SUBJECT: ISSUANCE OF AMENDMENT NO. 56 TO FACILITY OPERATING LICENSE
NO. NPF-29 - GRAND GULF NUCLEAR STATION, UNIT 1, REGARDING
SNUBBER SURVEILLANCE TESTING (TAC NO. 68980)

AMENDMENT NO. 56 TO FACILITY OPERATING LICENSE NO. NPF-29 - GRAND GULF

SUPPORTING AMENDMENT NO. 56 TO FACILITY OPERATING LICENSE NO. NPF-29

GRAND GULF NUCLEAR STATION, UNIT 1

FIGURE 4.7.4-1
 (SAMPLE PLAN 2) FOR SNUBBER FUNCTIONAL TEST

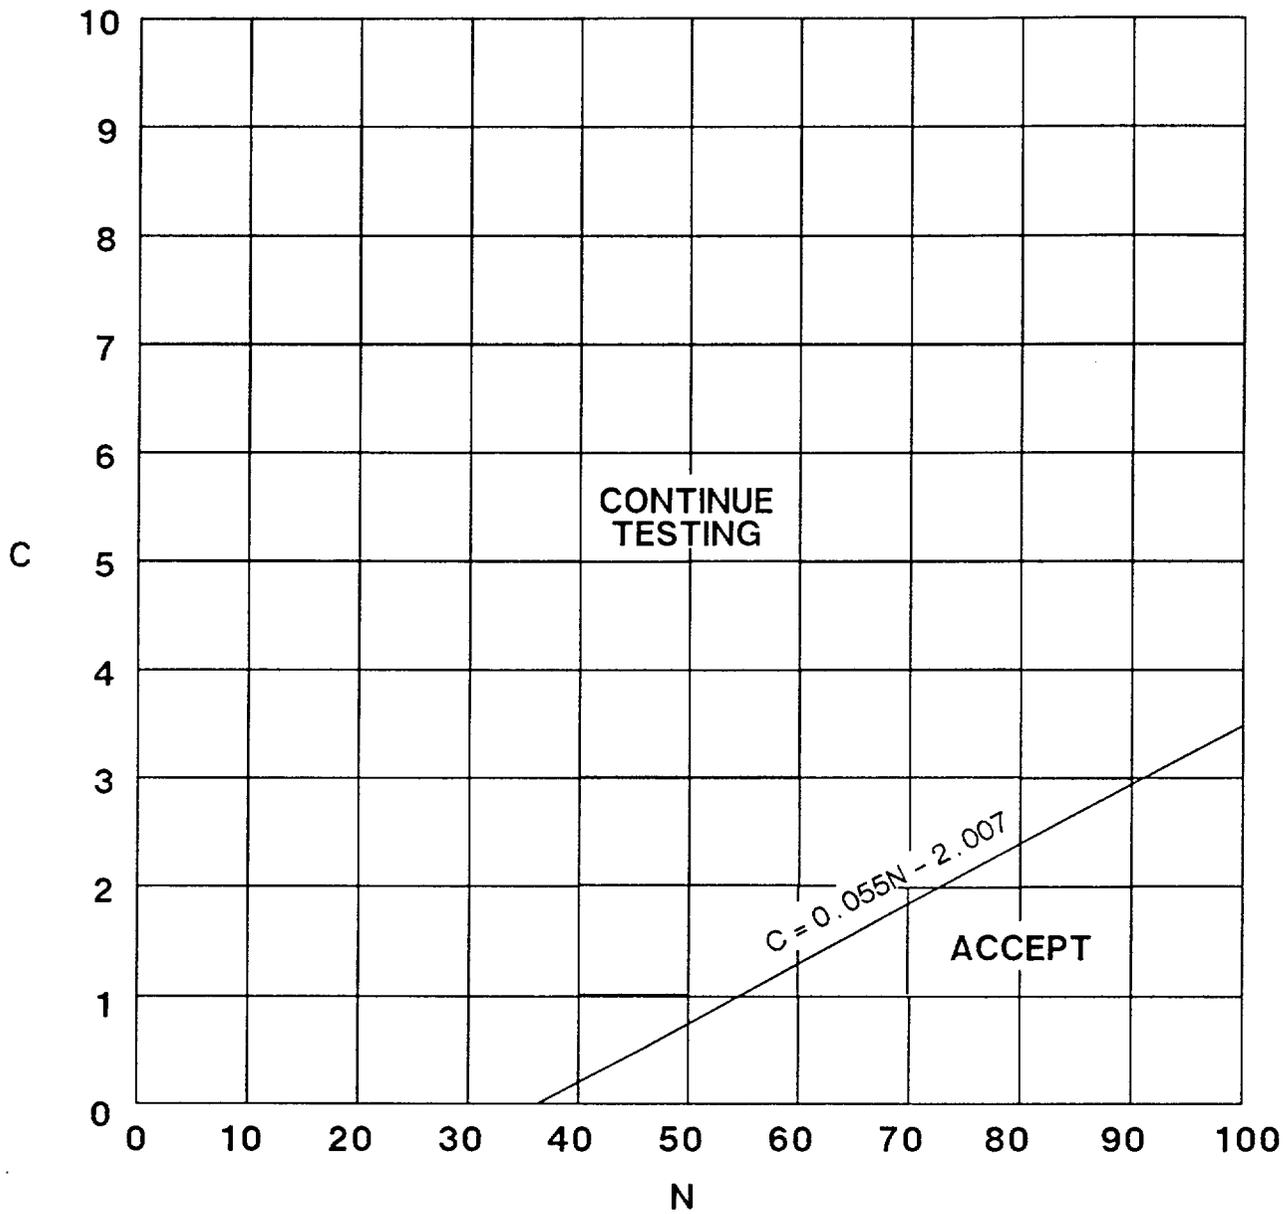
The amendment changes TS 3/4.7.4, "Snubbers," and the associated Bases by:
(1) changing sampling plan No. 2 to eliminate the requirement to test all snubbers if the number of rejected snubbers exceeds a specified number, and
(2) deleting sampling plan No. 3.

For Plan No. 2, test results for a given snubber type are plotted on TS Figure 4.7.4-1, where N is the number of snubbers tested and C is the number of test failures. The plot of test results falls into one of three regions: (1) the "accept" region which indicates that snubber type can be terminated; (2) the "continue testing" region which indicates that testing of that snubber type must continue, or (3) the "reject" region which indicates that all snubbers of that type are required to be tested. The "reject" region

of TS Figure 4.7.4-1 provides the possibility of rejecting a good population of snubbers and requiring functional testing of the entire snubber population. Functional testing of the entire population requires increased radiological exposure of test personnel.

The first change in the licensee's proposal is based on an analysis of Wald's sequential sampling plan. An evaluation of the Wald's sequential sampling plan formulas for acceptance and rejection numbers shows that reducing the probability of accepting a good population to zero, while holding constant the probability of accepting a bad population, has the effect of eliminating the "reject" region without significantly changing the accept region. Therefore, acceptance is essentially independent of rejection. The proposed change to eliminate the "reject" region maintains the currently approved acceptance criteria, while eliminating the potential for excessive snubber testing. These results were developed by the American National Standards Institute/American Society of Mechanical Engineers Code Committee (ANSI/ASME OM4 Committee) which develops standards for testing snubbers.

Although, the acceptance criteria in the Wald's sequential sampling plan are essentially independent of the rejection criteria, a slight dependence exists. The elimination of the rejection criteria without a corresponding change to the acceptance criteria will result in a very small increase in the probability of accepting a bad population. For the change being proposed, SERI has determined this negligible increase in probability to be less than 0.003. This determination was made by setting the probability of rejecting a good population to zero and then calculating the change in the probability of accepting a bad population required to duplicate the "accept" region of TS Figure 4.7.4-1.

- 2) A representative sample of each type of snubber shall be functionally tested in accordance with Figure 4.7.4-1. "C" is the total number of snubbers of a type found not meeting the acceptance requirements of Specification 4.7.4.f. The cumulative number of snubbers of a type tested is denoted by "N". At the end of each day's testing, the new values of "N" and "C" (previous day's total plus current day's increments) shall be plotted on Figure 4.7.4-1. If at any time the point plotted falls in the "Accept" region, testing of snubbers of that type may be terminated. When the point plotted lies in the "Continue Testing" region, additional snubbers of that type shall be tested until the point falls in the "Accept" region or all the snubbers of that type have been tested.

On the basis of this evaluation, we conclude that the proposed changes to the TS are acceptable because the acceptance criteria for surveillance testing of snubbers remain essentially unchanged. Also, the proposed changes do not significantly reduce the previous confidence level of snubber population acceptance and have no significant effect on the structural integrity of safety-related systems or margins of safety. In addition, radiological exposure to test personnel would be reduced with little, if any, increase in the probability of accepting a bad population of snubbers.
